Automatic Pallet Loader

Replacing the Picker Mate Tabs

Document Number
719-00979A-A

11 Mar 2008

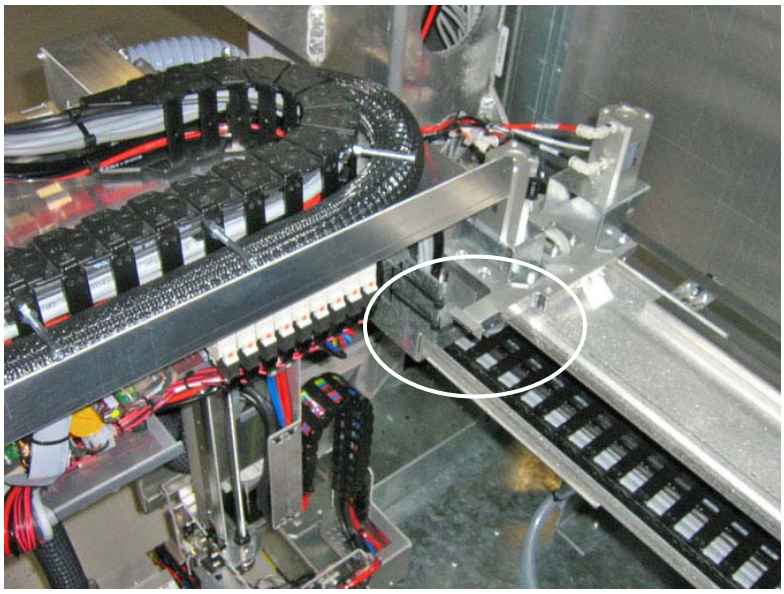
The picker mate tabs have been increased in length by 1.6 mm to reduce the risk of the picker and pusher colliding. Because the old tabs and the new tabs are visually almost identical, take care not to reinstall the old tabs after removing them.

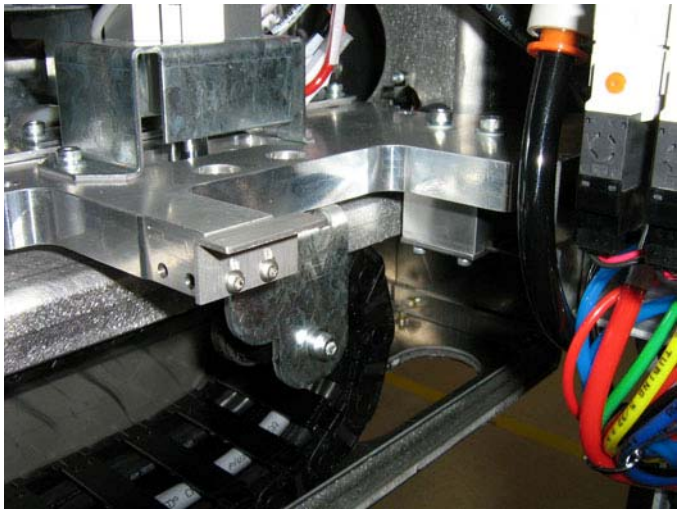
2. Remove and discard the old tabs and screws.

3. Install the new longer tabs using new screws from the kit.

4. Using the obrounds in the tab, adjust the height of the tab so that it is vertically aligned with the centre of the mate sensor on the pusher.
